## SUTHERLAND SHIRE COUNCIL ASSESSMENT REPORT

Panel Reference	2019SSH001
DA Number	DA18/1203
LGA	Sutherland Shire Council
Proposed Development	Demolition of existing structures and construction of a residential flat building with basement car parking and affordable rental housing component
Street Address	306 – 308 Taren point Road, Caringbah
Applicant/Owner	CHLY Pty Ltd
Date of DA lodgement	12 October 2018
Number of Submissions	4
Recommendation	Deferred Commencement – Approval
Regional Development Criteria (Schedule 7 of the SEPP (State and Regional Development) 2011	The application is referred to the SSPP as the development is for affordable housing under the State Environmental Planning Policy (Affordable Rental Housing) 2009. Development application that have a capital investment value of more than \$5 million for affordable housing purposes meet relevant criteria under the State Environmental Planning Policy (state & Regional Development) 2011 and are required to be determined by SSPP. The applicant's submission indicated the affordable housing component of the development has a CIV of \$5,052,277.00.

Breach of height shown dotted

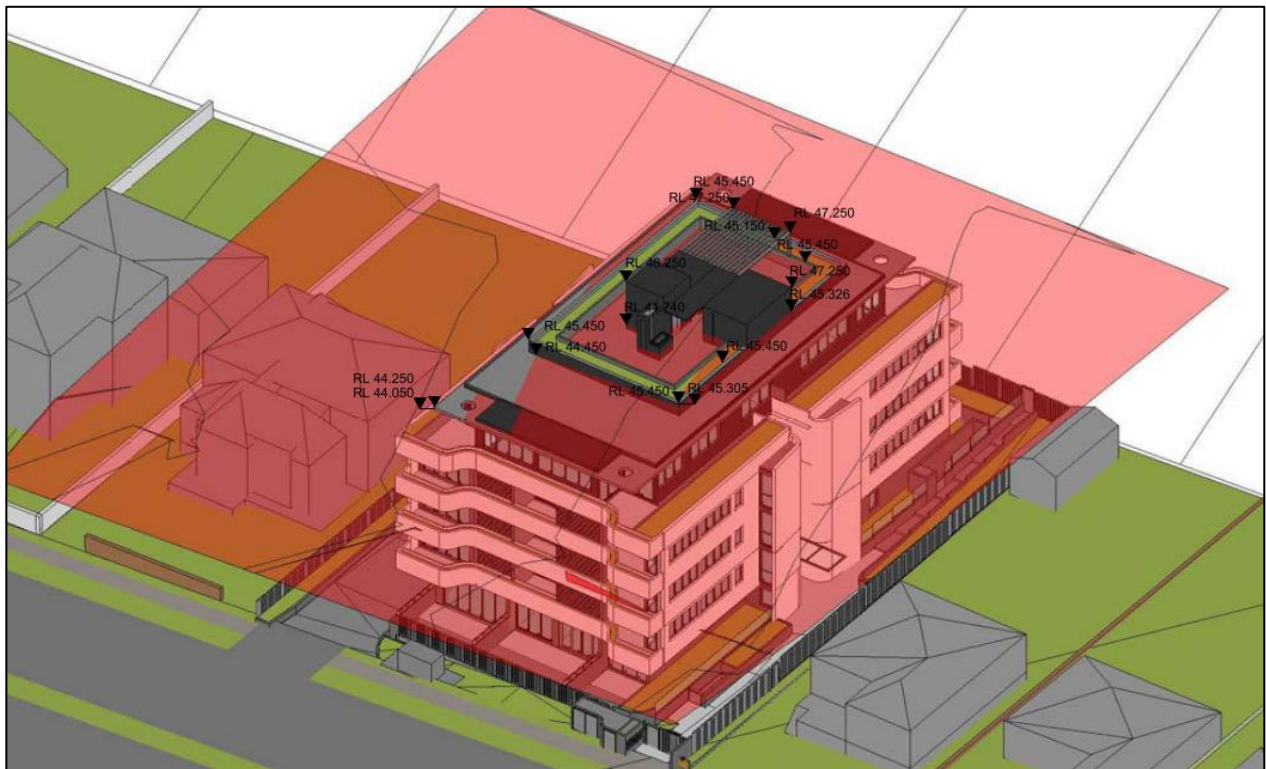
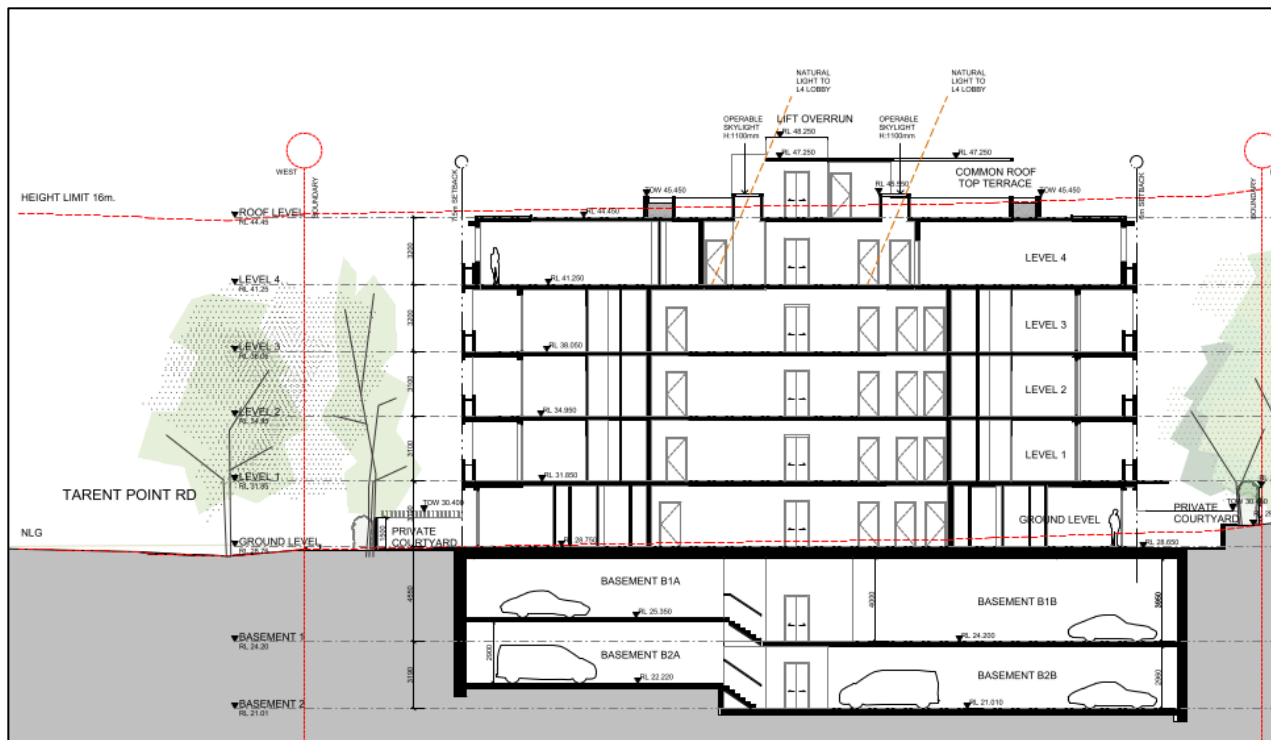
Clause 4.3 of SSLEP 2015 stipulates a maximum height of 16m for this site. The building has a maximum height of 19.4m (21.25% variation) to the top of the lift shaft and overrun which provides access to the communal roof top terrace. The height limit is also breached by other portions of the roof terrace being the fire stair, shade structure, WC and balustrade.

The north-western corner of the roof over Level 5 also breaches the height limit by approximately 0.2m.

The north-western corner of the roof over Level 5 also breaches the 16m height limit up to 200mm. This will not be perceivable in the overall bulk and scale of the building and is located to the north of the site limiting overshadowing of adjoining properties.

*Level 4 – Balconies and 2 rear living rooms setback are 6m instead of 9m*

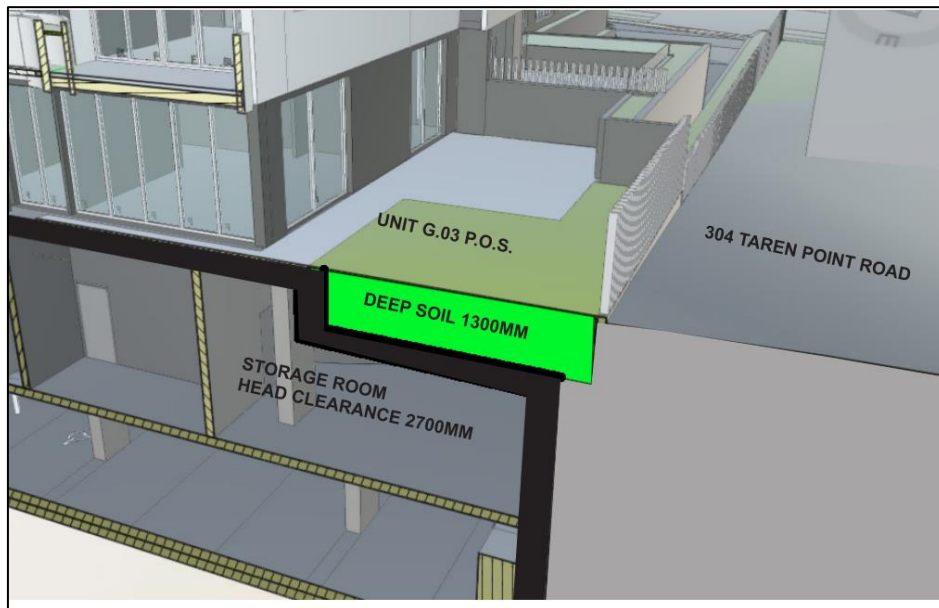
The uncovered section of all Level 4 balconies encroach into the 9m side and rear setback. However, the bulk of Level 4, being the covered balconies and internal floor space, remains setback 9m to modulate the built form to reduce the vertical scale of the building, overshadowing and overlooking. Planter beds are also provided along the edge of these balconies to minimise opportunity for overlooking.

The living areas to apartment 4.02 and 4.03 are setback 6m instead of 9m from the rear boundary. This is supported as the built form is centralised and will be mostly perceivable from the vacant site to the rear and not the adjoining properties to the north and south. The lack of an increased upper storey setback to these living rooms means that the centre of the rear elevation will have an unbroken 5 storey vertical scale. To obscure the vertical scale of this section the building 2 canopy trees are to be planted immediately on the rear boundary. No design changes are required to mitigate overlooking from the living room windows which currently look onto a vacant site. If the adjoining site to the east is developed it is highly likely a road will be constructed along the western boundary adjoining the subject site.
